SEMINOLE COUNTY GOVERNMENT
 1101 EAST FIRST STREET, 2ND FLOOR, WEST WING
 SANFORD, FLORIDA 32771

PROJECT NAME:	FOX VALLEY DR - PRE-APPLICATION	PROJ #: 24-80000037
APPLICATION FOR:	DR - PRE-APPLICATION DRC	
APPLICATION DATE:	3/08/24	
RELATED NAMES:	EP BRENDA PEARCE	
PROJECT MANAGER:	KATHY HAMMEL (407) 665-7389	
PARCEL ID NO.:	33-20-29-506-0C00-0010	
PROJECT DESCRIPTION	PROPOSED SPECIAL EXCEPTION FOR A NEW WATER METER SYSTEM INSTALLATION ON 0.32 ACRES IN THE PD ZONING DISTRICT LOCATED ON THE EAST SIDE OF FOX VALLEY RD, NORTH OF WEKIVA SPRINGS RD	
NO OF ACRES	0.32	
BCC DISTRICT	3-LEE CONSTANTINE	
CURRENT ZONING	PD	
LOCATION	ON THE EAST SIDE OF FOX VALLEY RD, NORTH OF WEKIVA SPRINGS RD	
FUTURE LAND USE-	PD	
APPLICANT:	CONSULTANT:	
BRENDA PEARCE BLACK & VEATCH/SUNSHINE WATER 200 WEATHERSFIELD AVE ALTAMONTE SPRINGS FL 32714 (678) 656-5179 PEARCEB@BV.COM	N/A

PROJECT AREA ZONING AND AERIAL MAPS

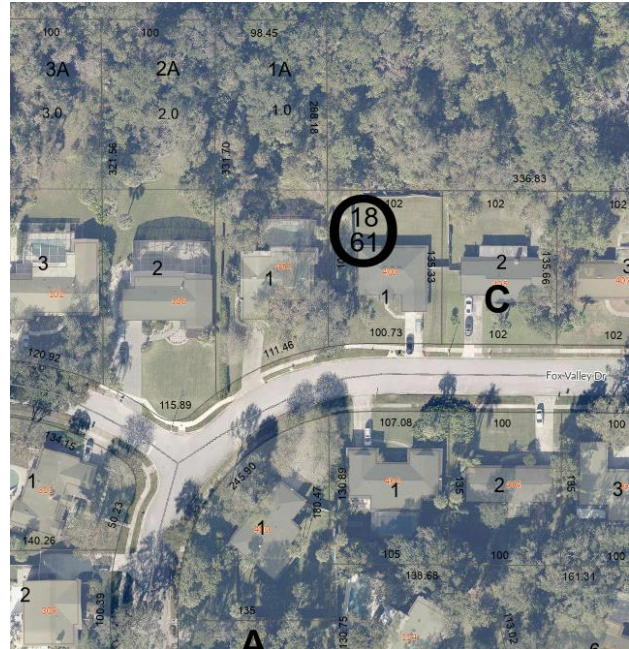
The parcel is located within unincorporated Seminole County and within the Sweetwater Oaks Planned Development (PD).

The installation of a pole with an antenna for a new water metering system will require a Major Amendment to allow the use in the PD. A variance to the building/structure height of 35 feet may also be required.
